ROCKY FLATS ENVIRONMENTAL TECHNOLOGY SITE ER REGULATORY CONTACT RECORD

Purpose of Contact: Bowman's Pond PCB Remediation

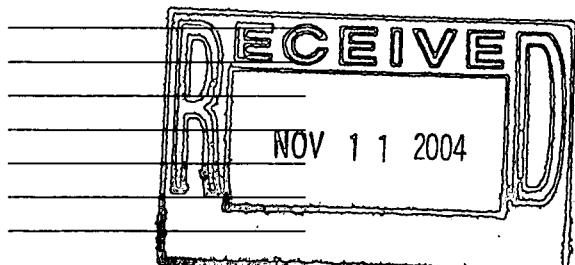
The attached map shows the results of the most recent excavation and confirmation sampling at Bowman's pond. EPA and CDPHE concurs the following:

1. Backfill the "pond" area and the "hot spot" area with on-site soil since the PCB samples showed concentrations below action levels.
 2. Continue excavation in the "ditch" area west of the "pond" that showed PCB levels above action levels. The excavation will remove a minimum of 2 feet of soil in the bottom of the ditch and expand the lateral extent a minimum of 3 feet in any direction that showed concentrations above action levels.
 3. Temporary soil berms will be put into place to control surface water flow from up gradient contaminated areas to down gradient "clean" areas.
-
